JRPP REPORT

JOINT REGIONAL PLANNING PANEL (Sydney East Region)

JRPP No	2015SYE139
DA Number	DA-2015/431
Local Government Area	Willoughby City Council
Proposed Development	Redevelopment of Artarmon Public School
Street Address	5 Abbott Street, ARTARMON NSW 2064
Applicant/Owner	Mr Patrick Arthur Timmins / NSW Department of Education and Communities
Number of Submissions	3
Regional Development Criteria (Schedule 4A of the Act)	Capital Investment Value (CIV) of the proposal is \$20,148,436.
List of All Relevant s79C(1)(a) Matters	WLEP 2012; Deemed SEPP Sydney Regional Environmental Plan (Sydney Harbour Catchment) 2005; State Environmental Planning Policy (Infrastructure) 2007; SEPP 65; Draft WLEP; WDCP; S94A Plan.
List all documents submitted with this report for the panel's consideration	A3 Plans
Recommendation	Approval
Report by	Ana Vissarion - Development Planner
Report date	14 April 2016

JRPP NO: 2015SYE139
COUNCIL: WILLOUGHBY CITY COUNCIL
ADDRESS: 5 Abbott Road, ARTARMON NSW 2064.
DA NO: DA-2015/431
ATTACHMENTS: 1. PLANS AND ELEVATIONS
DATE: 08-MAR-2016

Figure 4-3: Section Plans

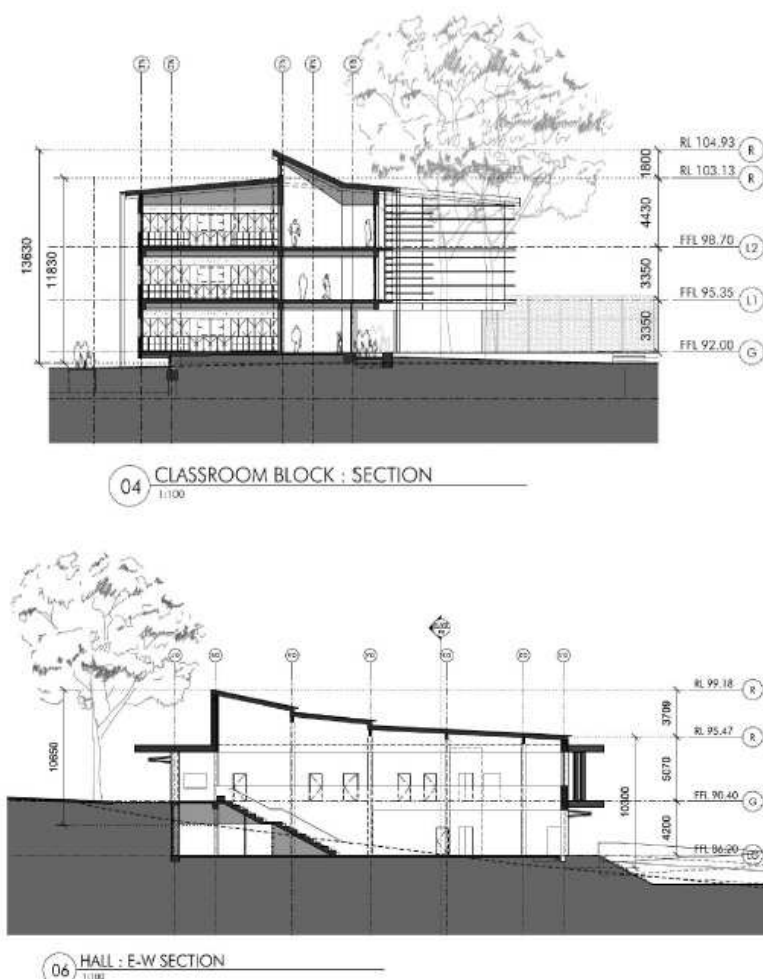
Sections through the Classroom/Homebase Block (13.63m high) and the new Hall (10.65m high), both exceeding the maximum height of buildings standard in WLEP 2012 - architectural plans and sections prepared by the NSW Public Works Government
